MIL-M-28787/186B
AMENDMENT 2
16 December 1992
SUPERSEDING
AMENDMENT 1
20 September 1983

MODULES, STANDARD ELECTRONIC

GENERATOR, FUNCTION, MSB, ANALOG, KEY CODE SHY

FIGURE 19. Continuity test circuit for table XIV.

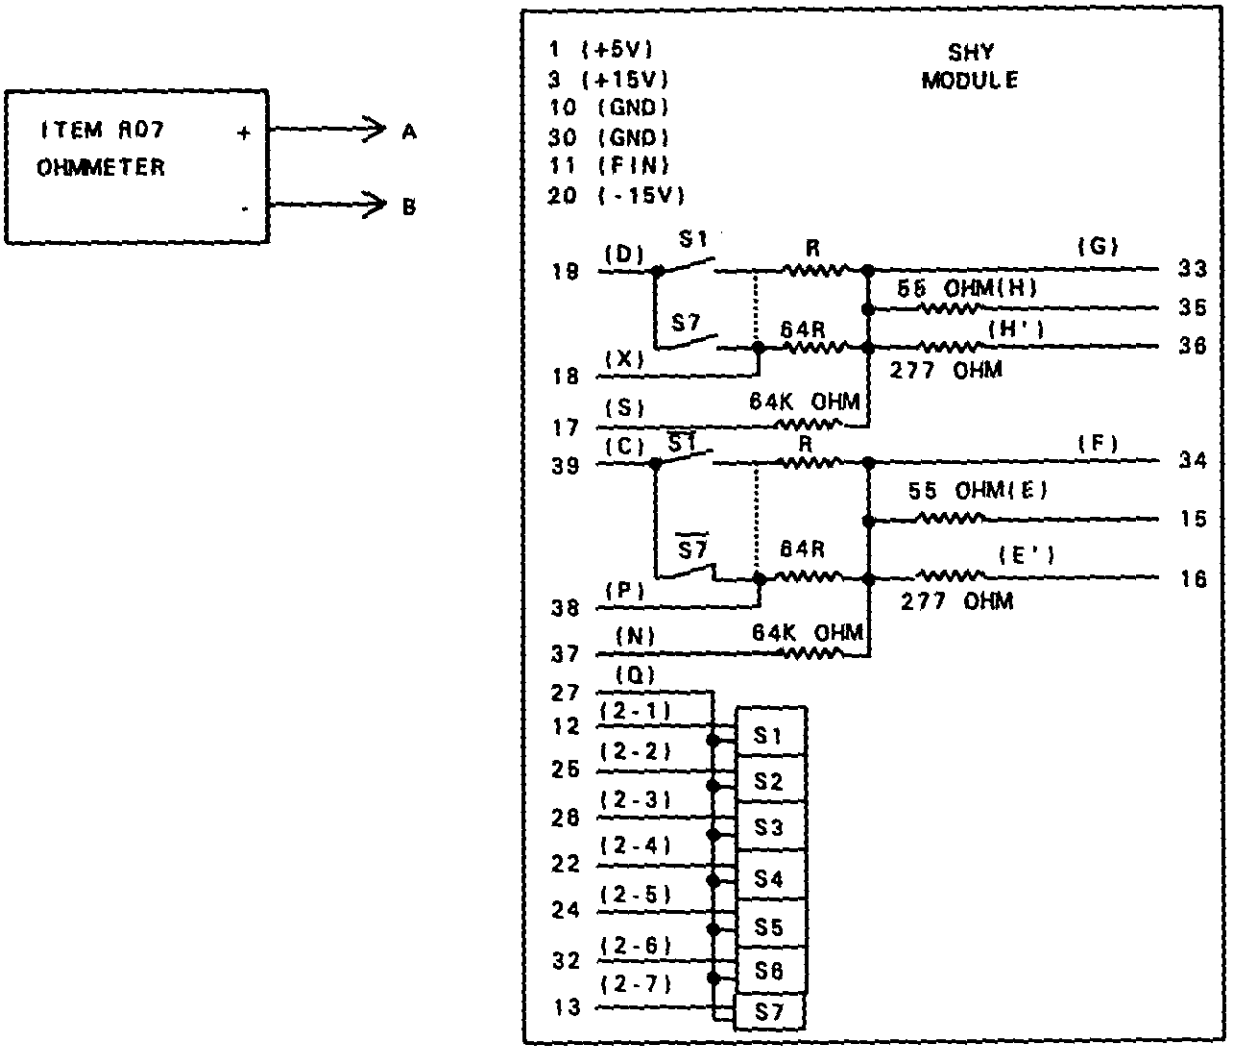
FIGURE 19: Delete and substitute new figure 19 as printed on page 4 of this amendment.

NOTE: For test condition N3, penetrate the anodized finish on the module fin with a sharply pointed probe connected to the negative terminal.

FIGURE 20. Settling time test circuit for table XV.

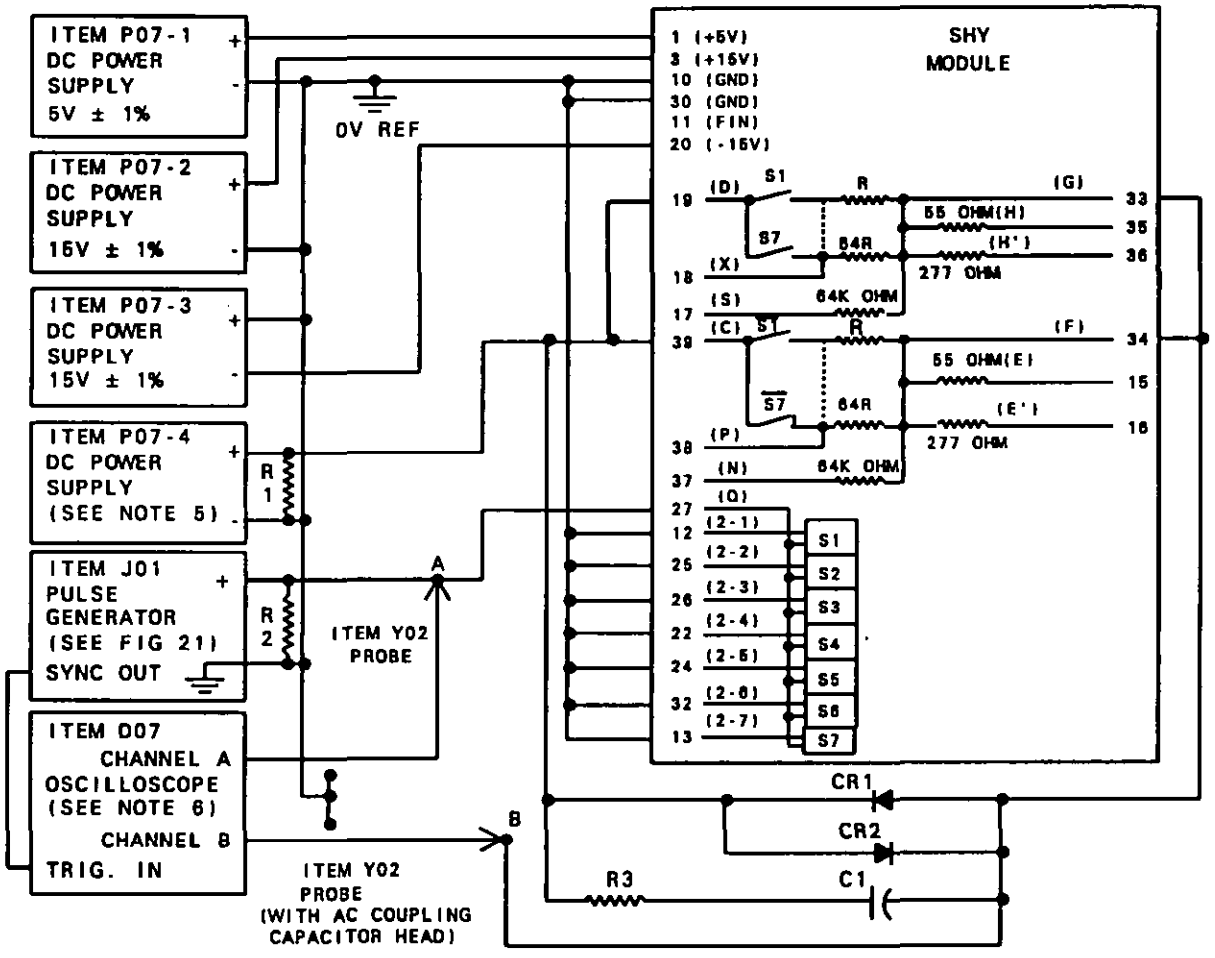
*FIGURE 20: Delete and substitute new figure 20 as printed on page 5 of this amendment.

1. R1 = R2 = 50 Ohm ± 5 percent, 1 W.
2. R3 = 750 Ohm ± 1 percent, 1/8 W.
3. C1 = 220 pF ± 5 percent, 20 WVdc.
4. CR1 = CR2 = 1N4148, or equivalent.
5. For test conditions P1 and P2, adjust power supply P07-4 for 6.0 V ± 1 percent and for test conditions P3 and P4, adjust power supply P07-4 for 1.1 V ± 1 percent.
6. Oscilloscope D07 shall be ac coupled so that channel B can be amplified for maximum amplitude or a dc voltage can be subtracted by means of a differential comparator. Verify that channel B output amplitude stays within ± 1 mV of its settled out value at 6.0 uS after the input pulse.

FIGURE 22. 800 Hz angular accuracy test circuit for table XVI.

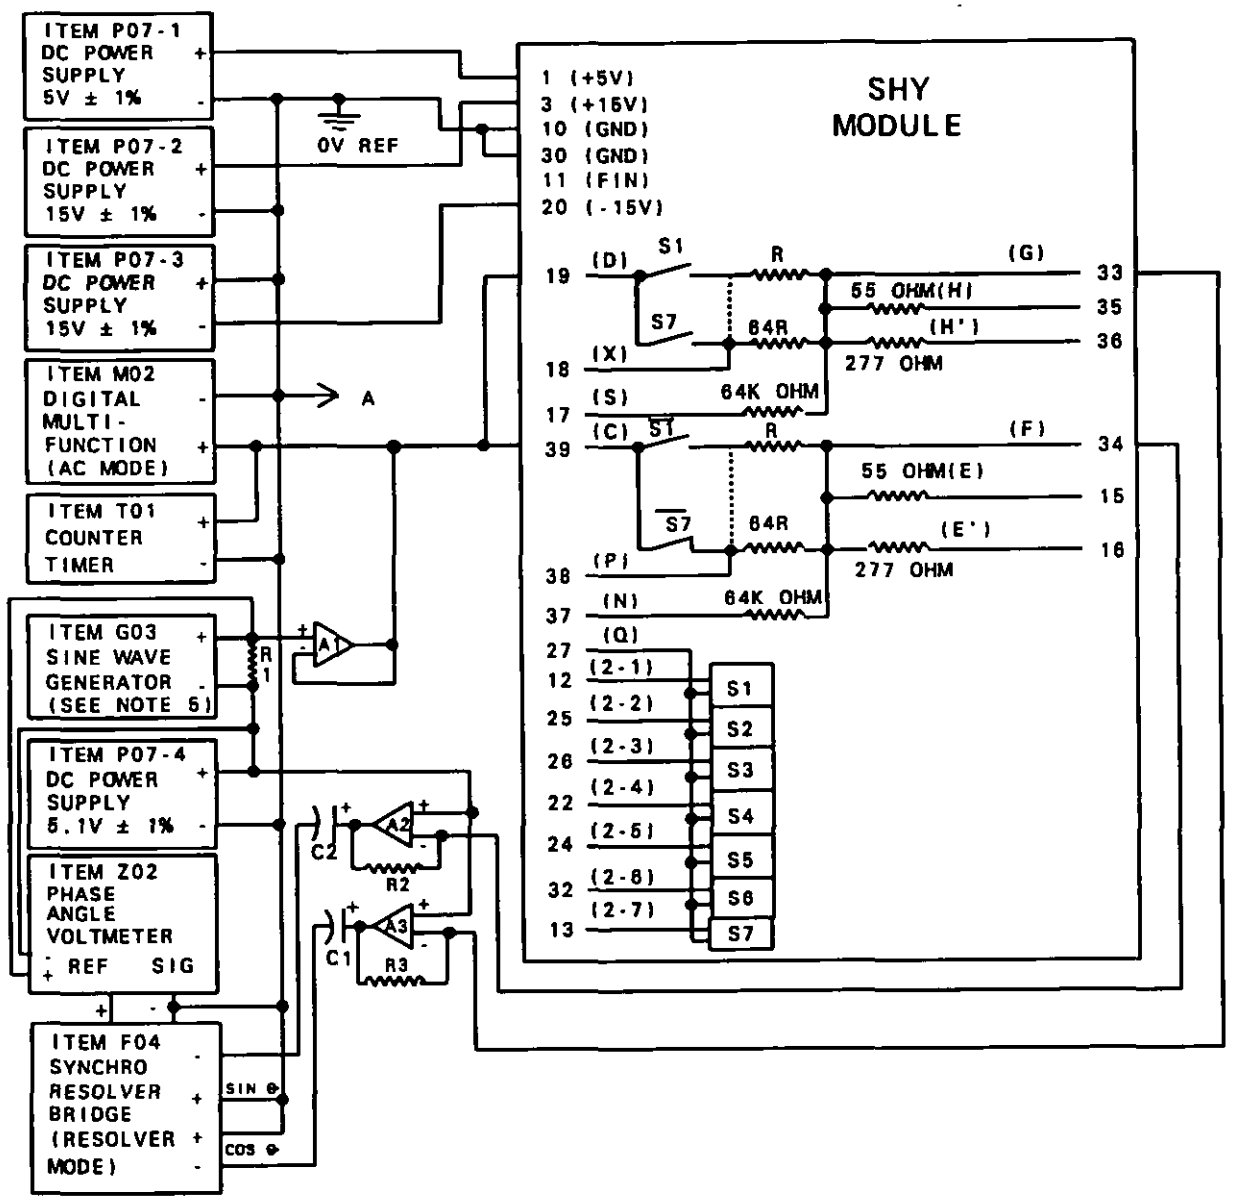
FIGURE 22: Delete and substitute new figure 22 as printed on page 6 of this amendment.

NOTES:
1. R1 = 600 Ohm ± 5 percent, 1 W.
2. R2 = R3 = 500 Ohm ± 0.01 percent (matched to ± 0.002 percent), 1/8 W.
3. C1 = C2 = 100 uF ± 5 percent, 20 WVdc, electrolytic.
4. A1-A3 = uA741, or equivalent.
5. Item G03 setup (verified at pins 19 and 39):
   Amplitude = 3.2 ± 0.1 Vrms.
   Frequency = 800 ± 8 Hz.
